EPC STORMWATER REVIEW COMMENTS
IN ORANGE BOXES WITH BLACK TEXT

ESTATES AT CATHEDRAL PINES

STREET IMPROVEMENT PLANS

STORM SEWER AND POND PLANS

**SOUTH POND SECTION A-A PROFILE
STA 1+00.00 TO 2+26.17**

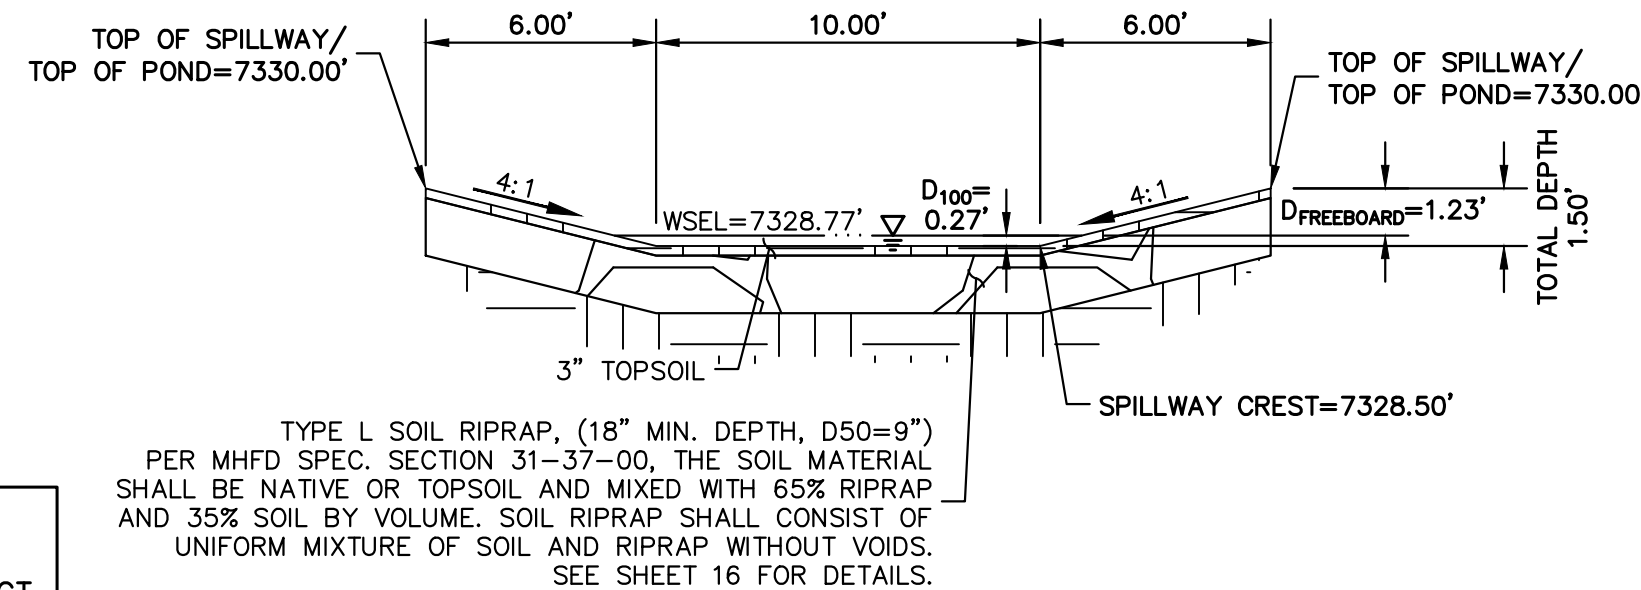
Consider widening the trickle channel for ease of maintenance. The bucket width of a small walk-behind skid steer is 36" wide, so a 40" trickle channel can allow for ease of maintenance.

**SOUTH POND SECTION B-B PROFILE
STA 1+00.00 TO 2+18.39**

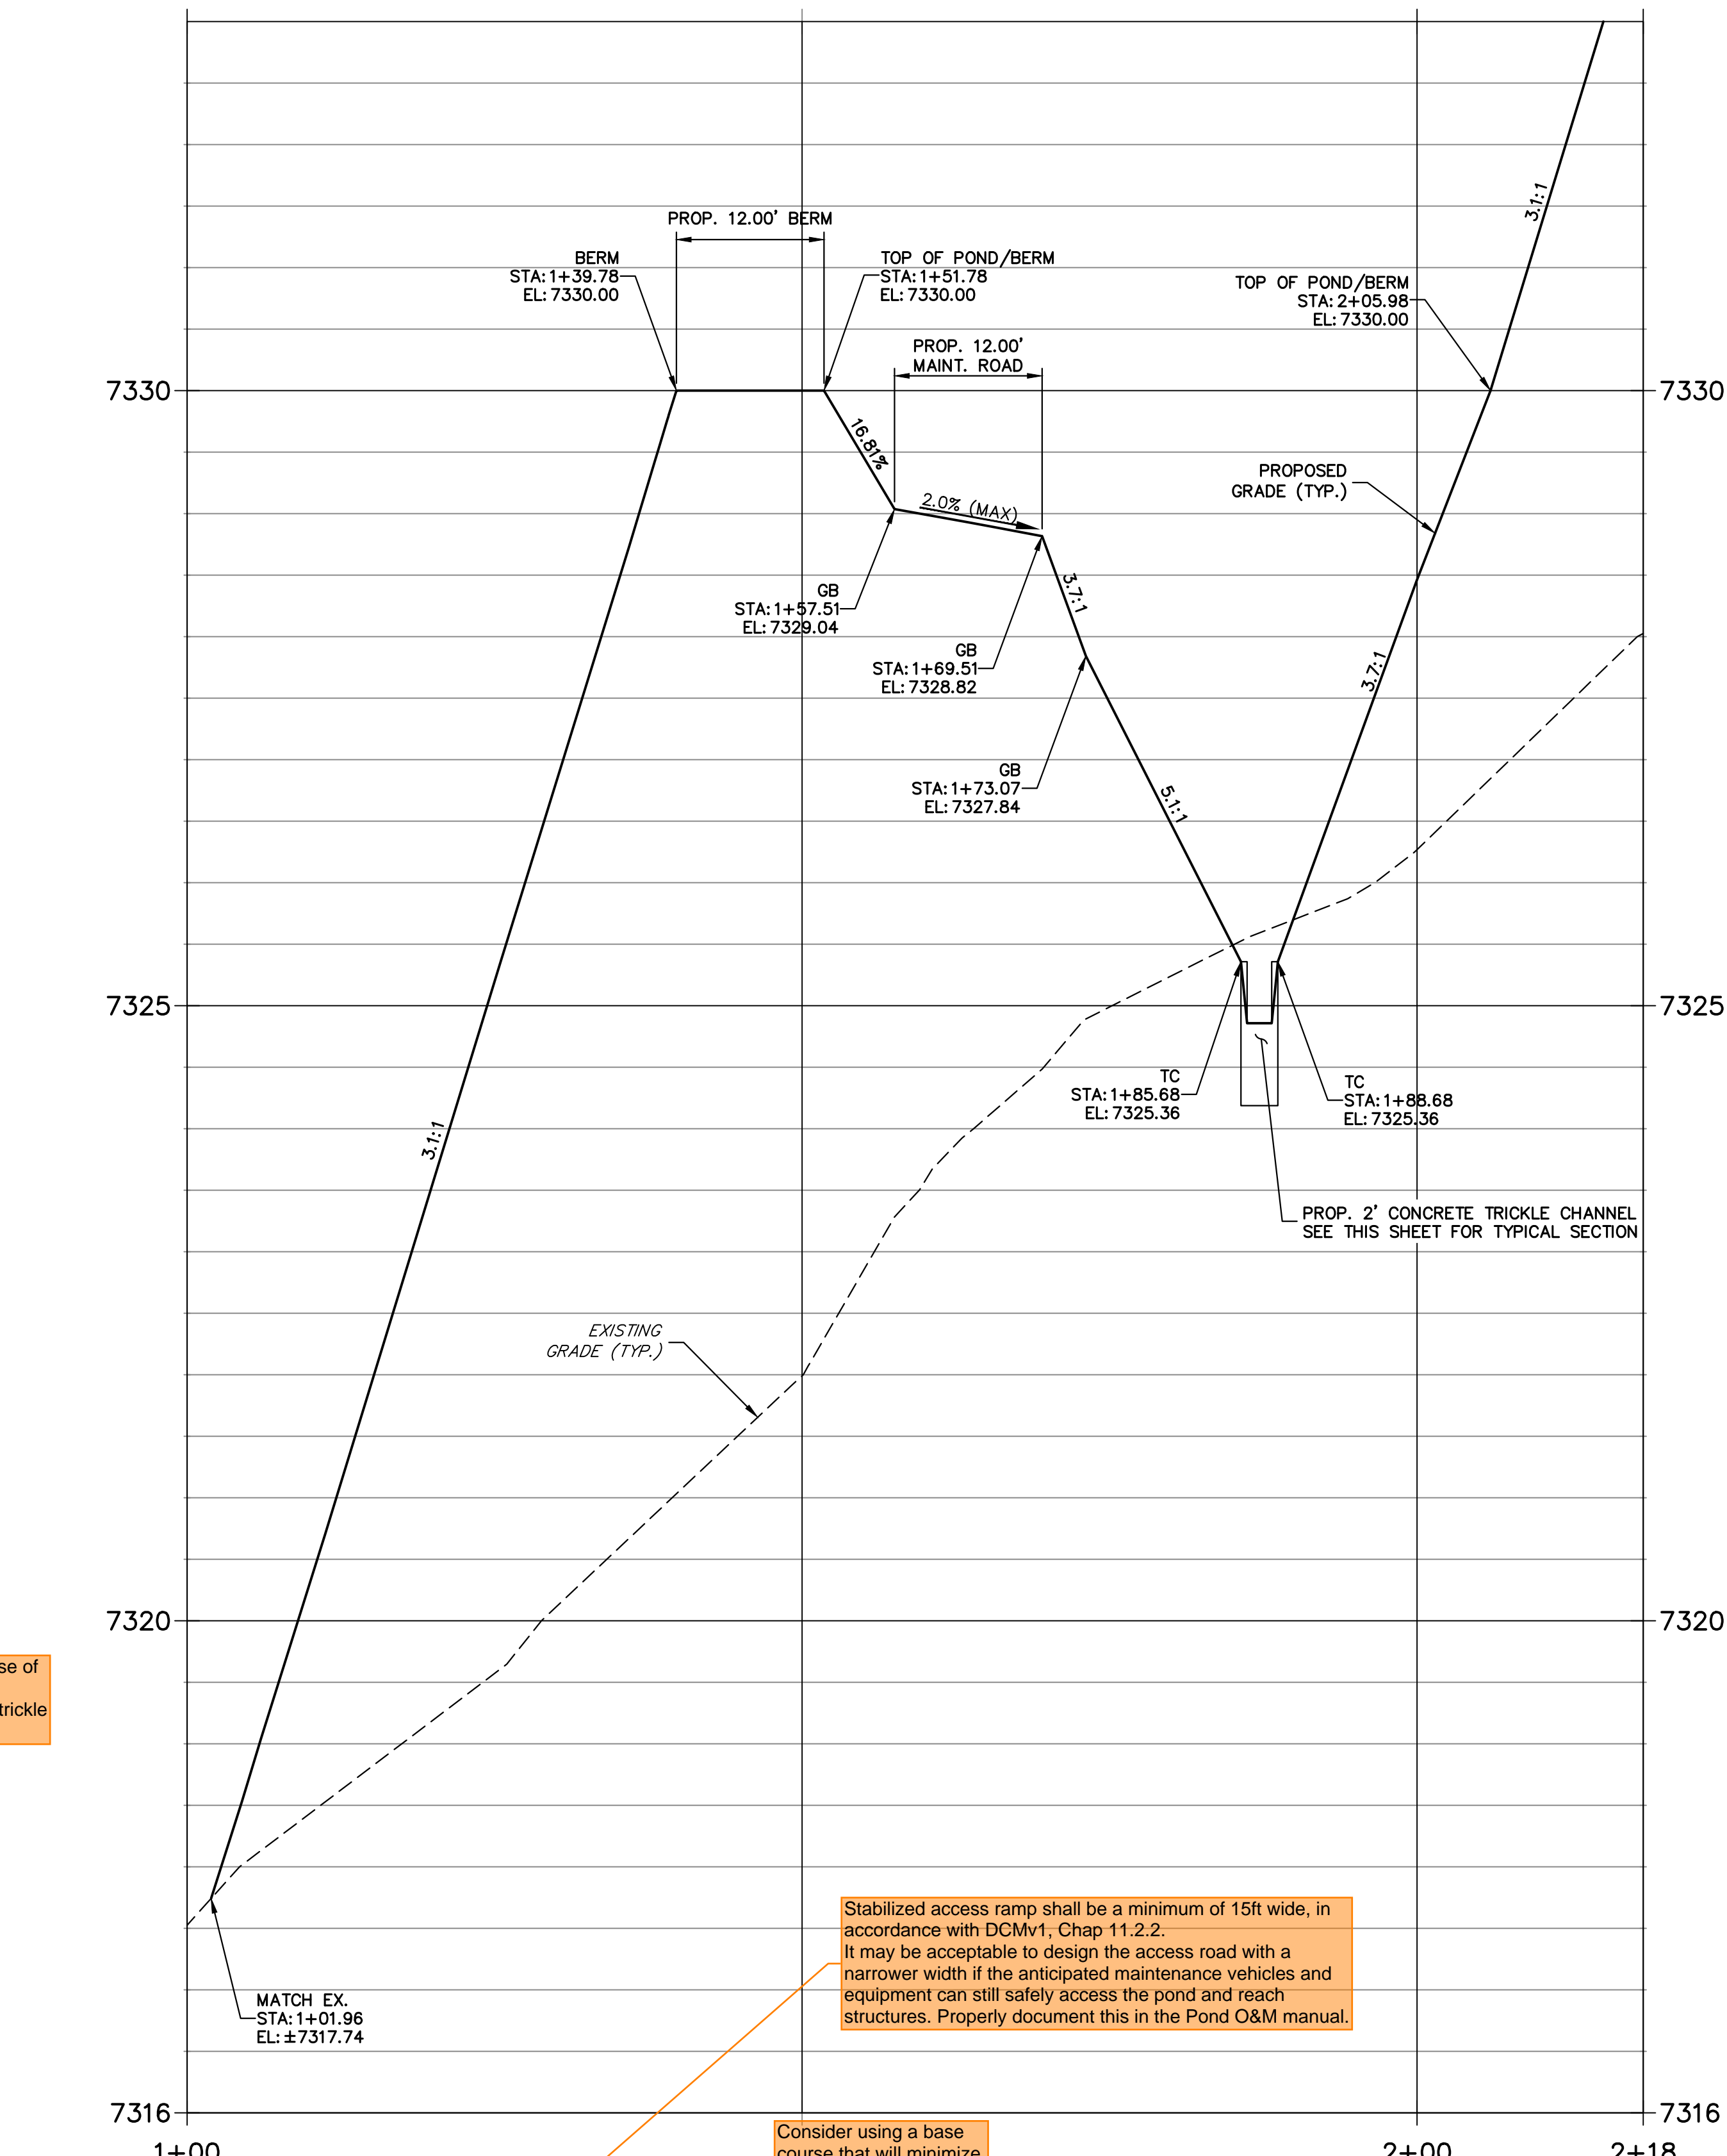
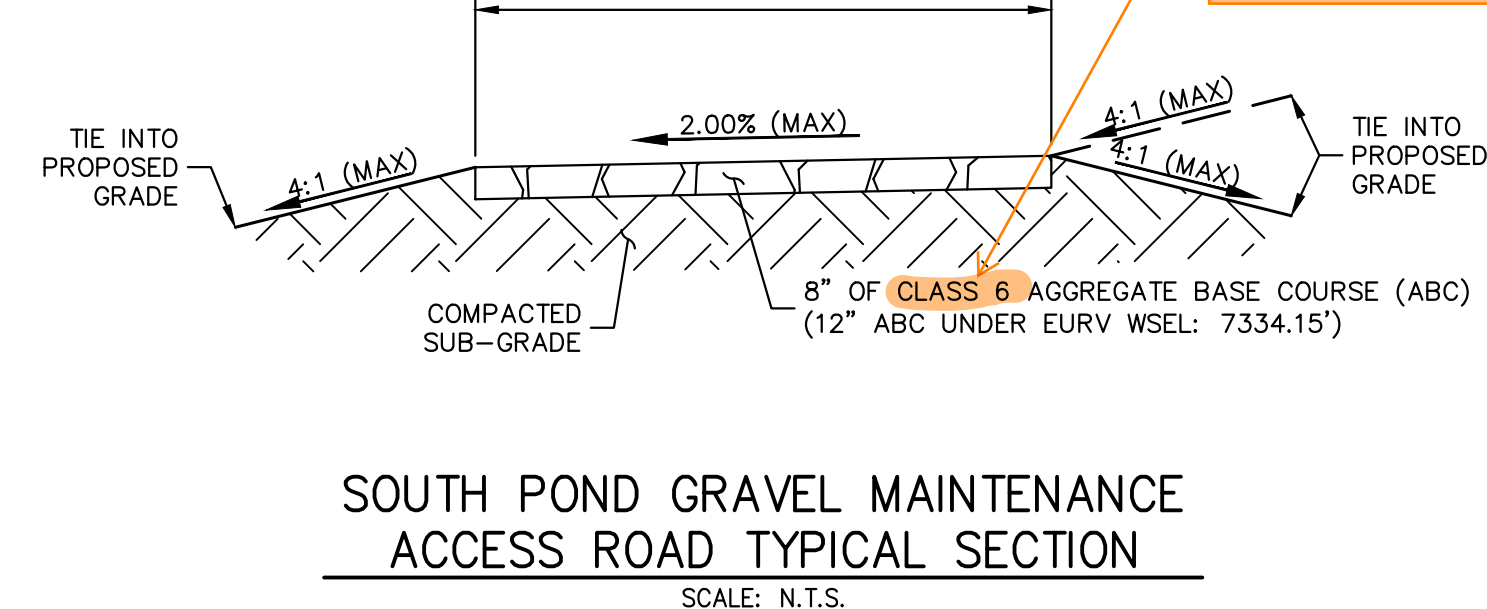
Stabilized access ramp shall be a minimum of 15ft wide, in accordance with DCMv1, Chap 11.2.2. It may be acceptable to design the access road with a narrower width if the anticipated maintenance vehicles and equipment can still safely access the pond and reach structures. Properly document this in the Pond O&M manual.

Consider using a base course that will minimize migration of fines when the pond is detaining water.

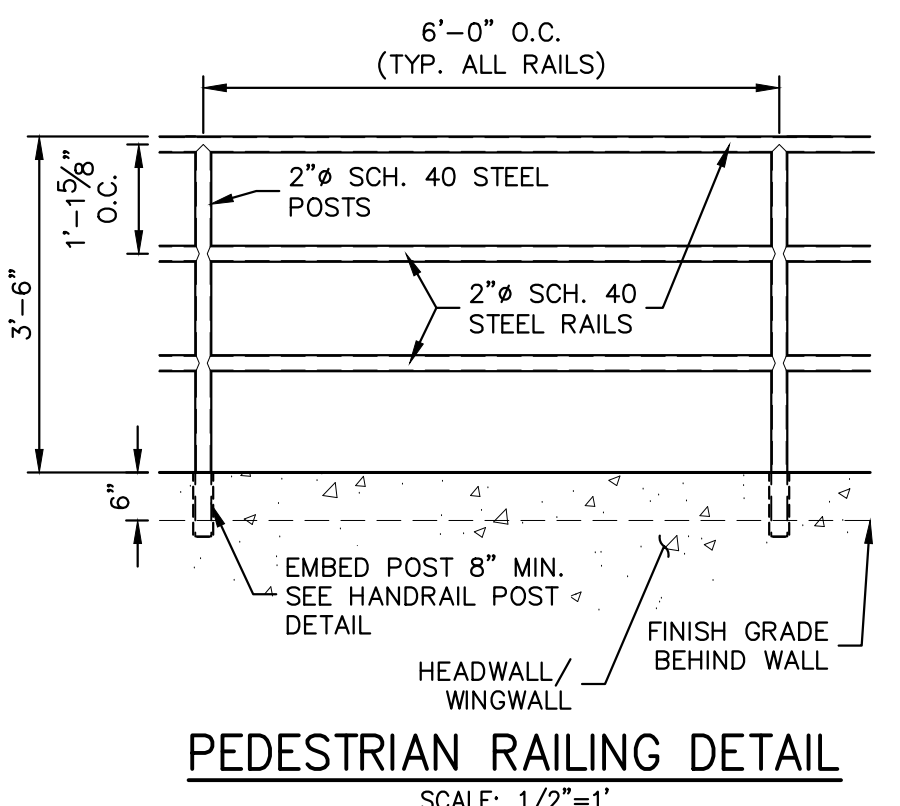
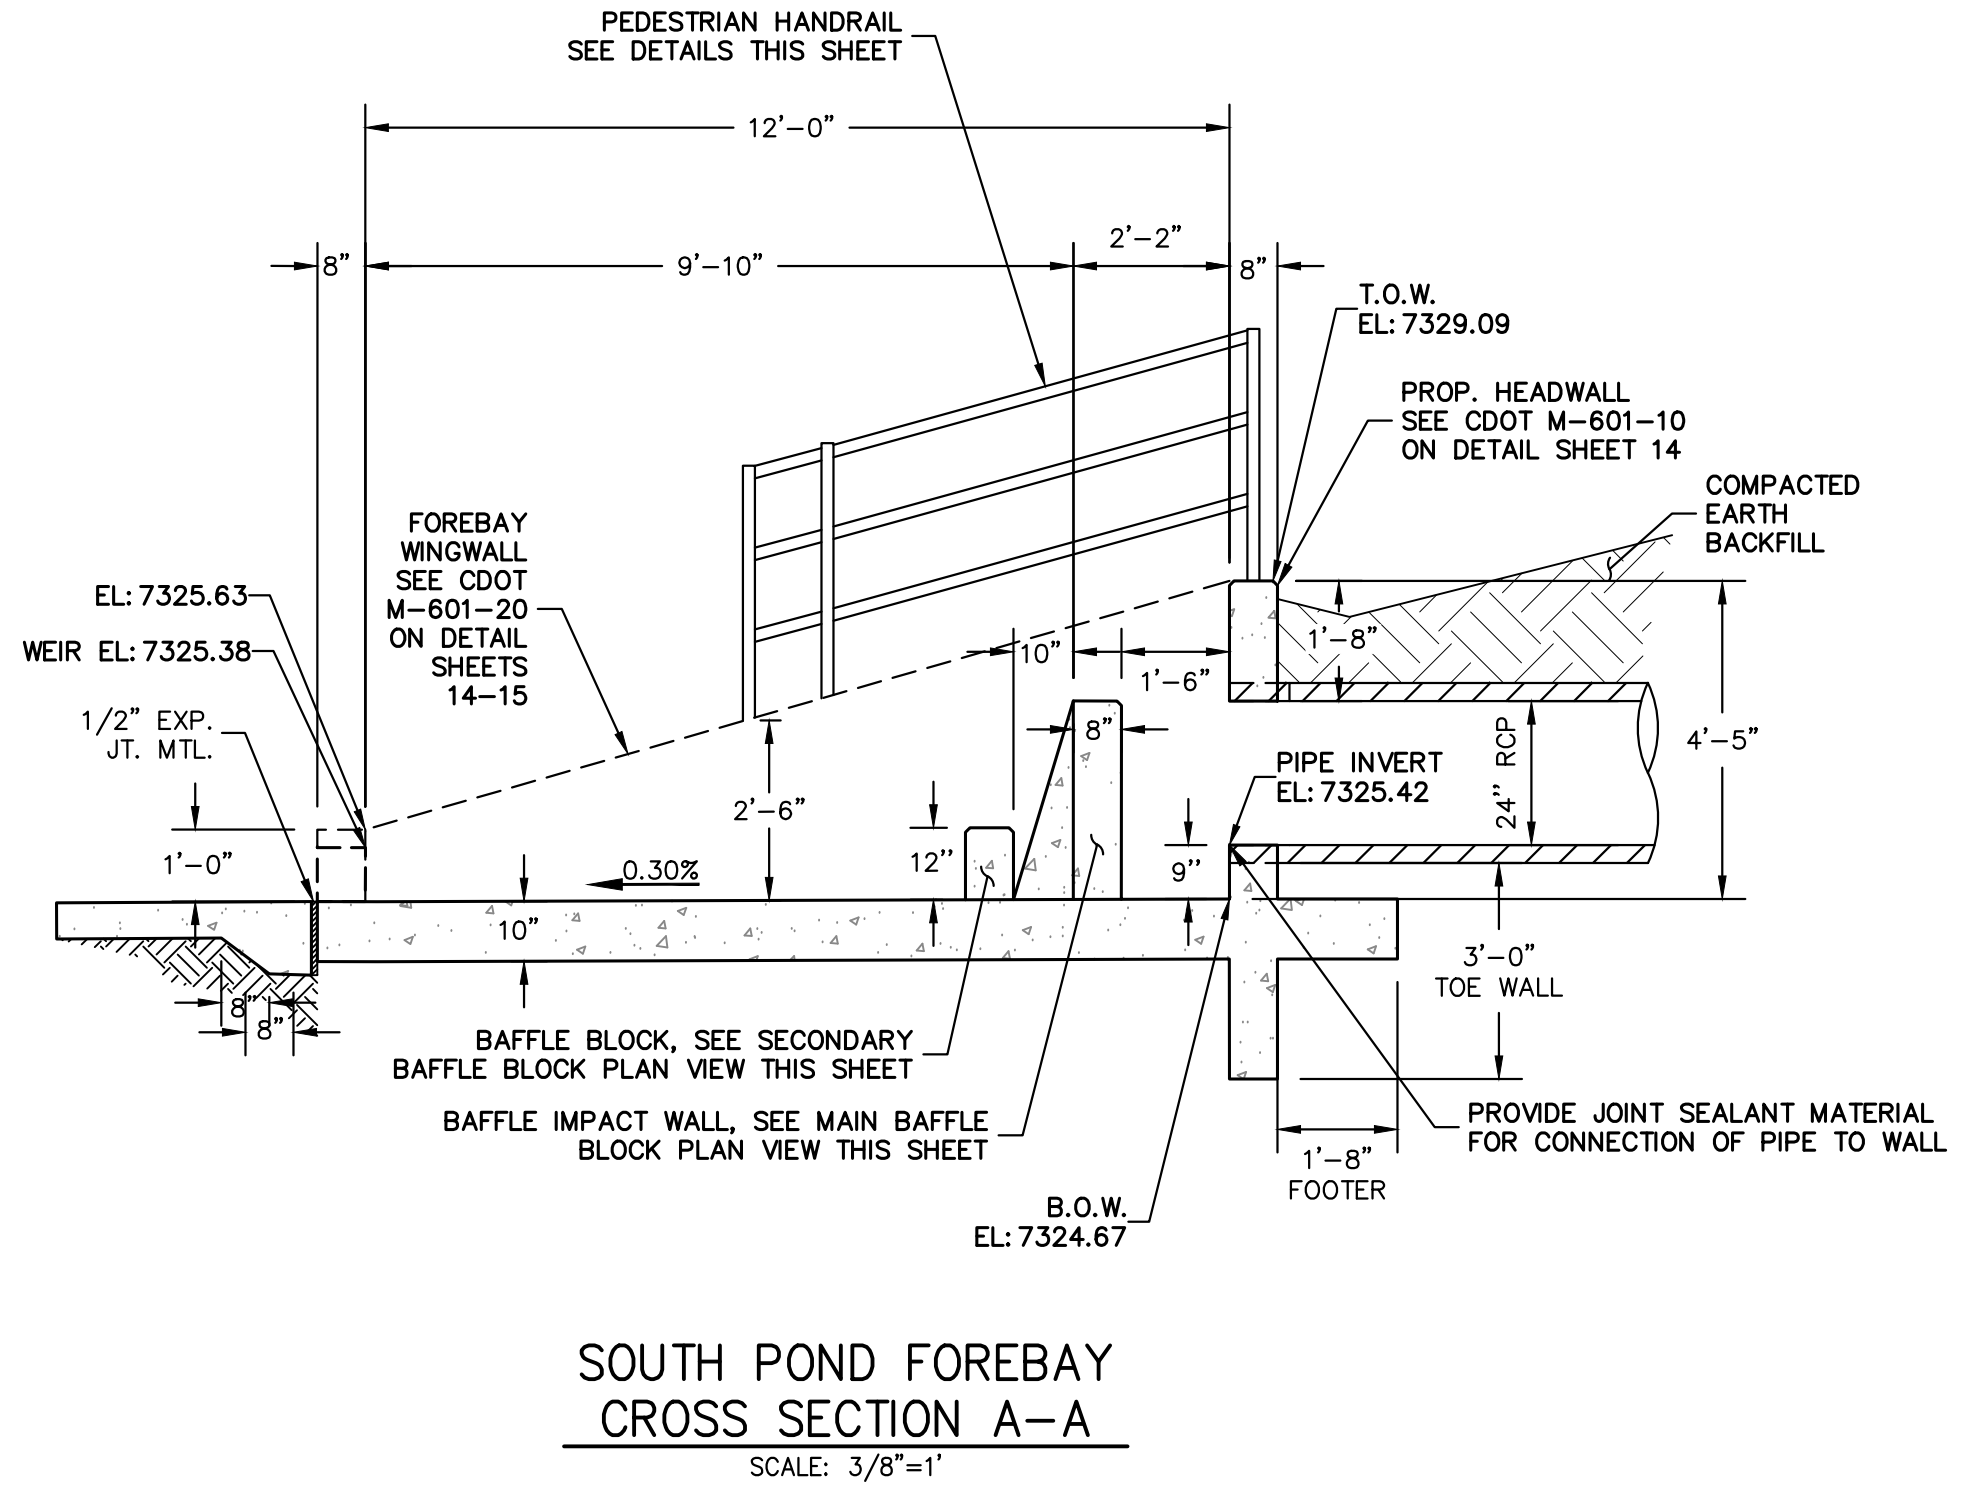
Forebay's notch width of the south pond is 4 inches. Please revise it to match the FDR calculation.
